Review of baseline data collected for Carmichael Coal Mine project, and implications for Groundwater Dependent Ecosystems including the Doongmabulla Springs Complex

Matthew Currell, PhD
Associate Professor (Environmental Engineering)
School of Engineering
RMIT University
GPO Box 2476
Melbourne VIC 3001

2nd June, 2021

Fig 1 – Map of groundwater monitoring bores provided in Adani GMMP (AECOM, 2019).

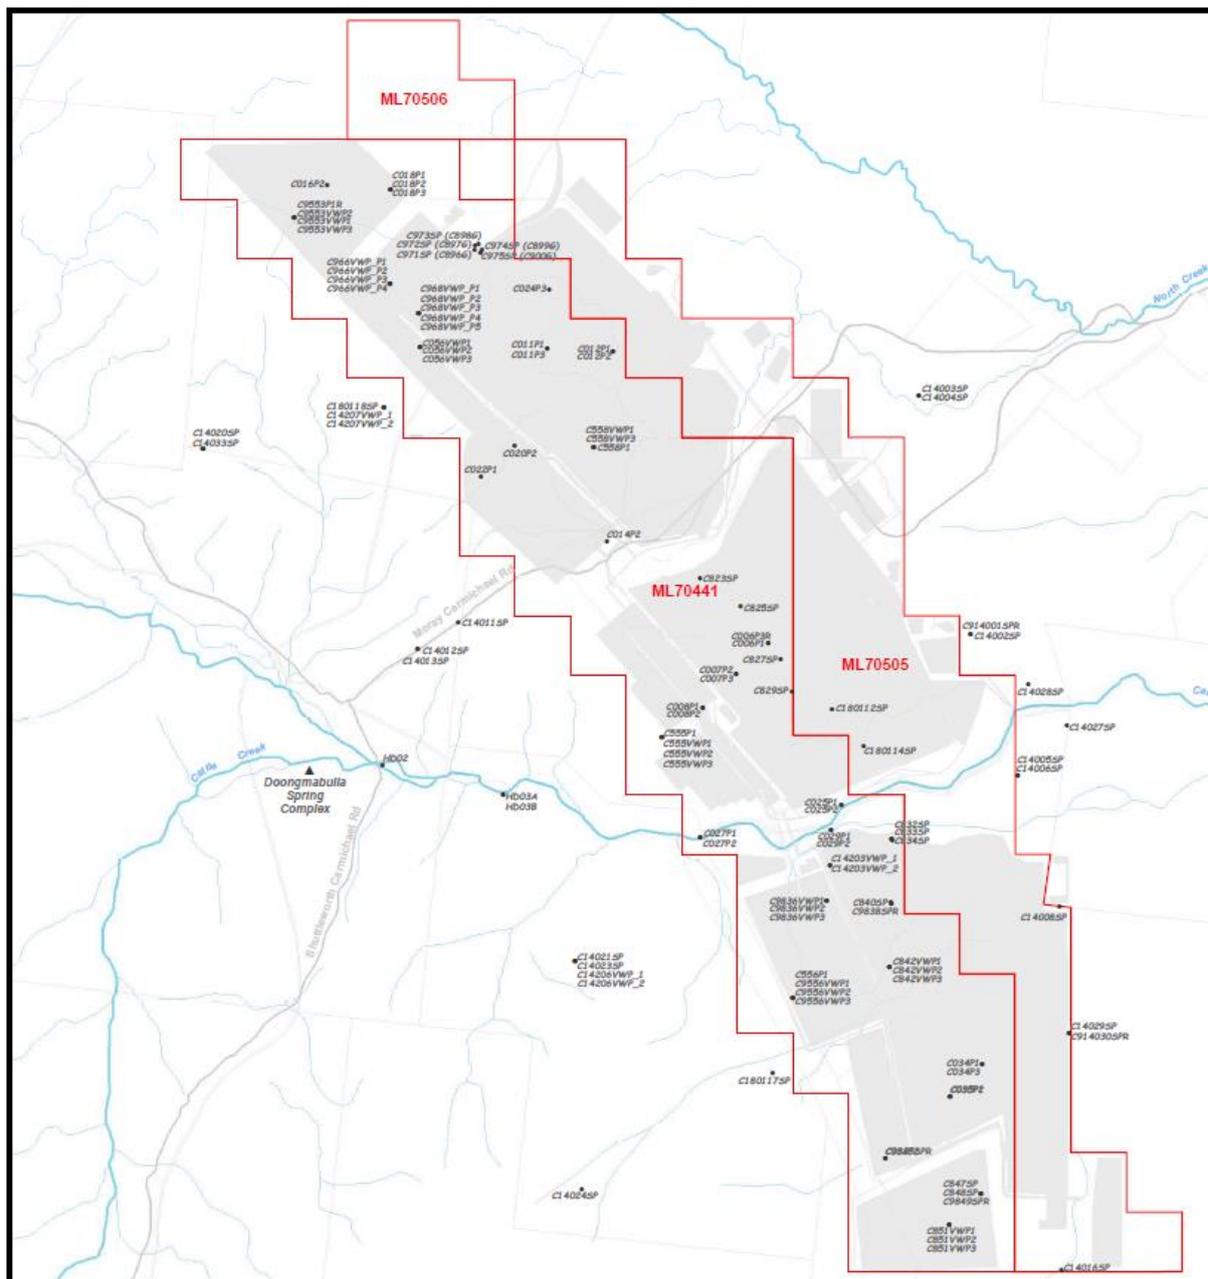
I note that some newer groundwater monitoring bores have subsequently been constructed closer to the springs; however, I do not believe there has been a sufficient period of time and sampling frequency prior to commencement of mine construction on the site, to characterise a comprehensive baseline.

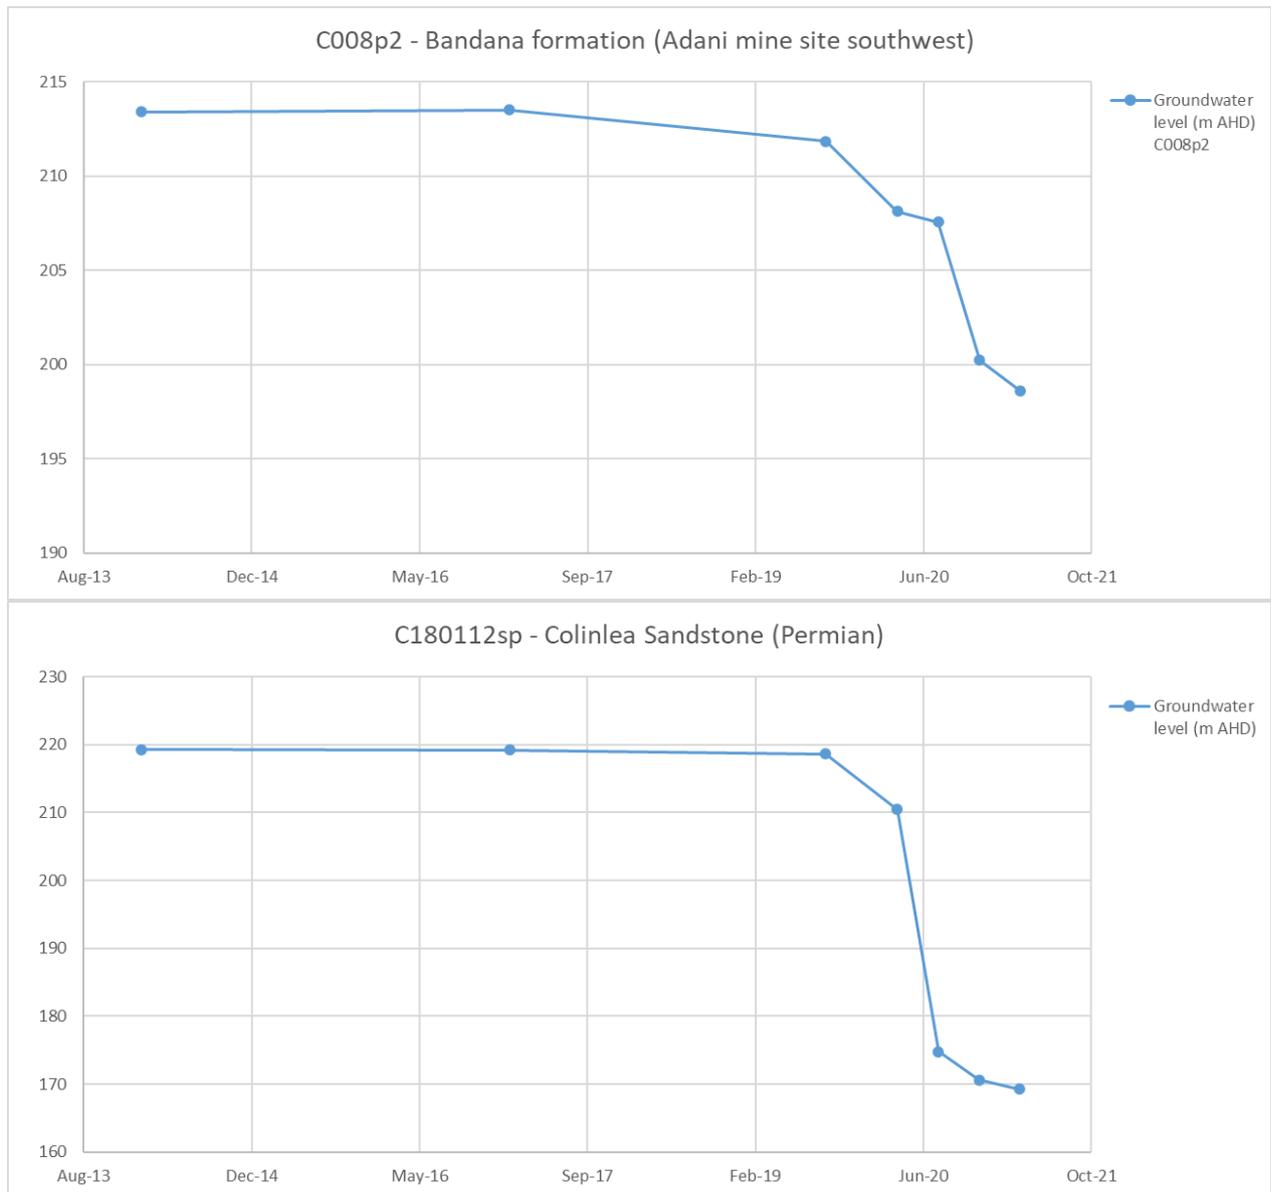
2. Based on an analysis of groundwater level data reported by Adani/Bravus on their website (see Fig 2 and hydrographs in Appendix A), it appears substantial de-watering activity has been taking place at the mine site since late 2019 and continued throughout 2020 – as seen by

a significant drop in groundwater levels within coal-bearing aquifer units from this time onwards:

Based on my assessment of the publicly available groundwater data and reporting, my opinion is that many of these requirements – particularly those highlighted in **bold** in the above text – are not contained within the approved version of the GDEMP and to my knowledge these requirements have not been subsequently satisfied through additional data and analysis in other documentation. It is thus concerning to note evidence that substantial modification of the region's groundwater hydrology (e.g. large reductions in groundwater levels due to de-watering activity) has already occurred on the site (see Fig 2) before these baseline requirements have been fulfilled.
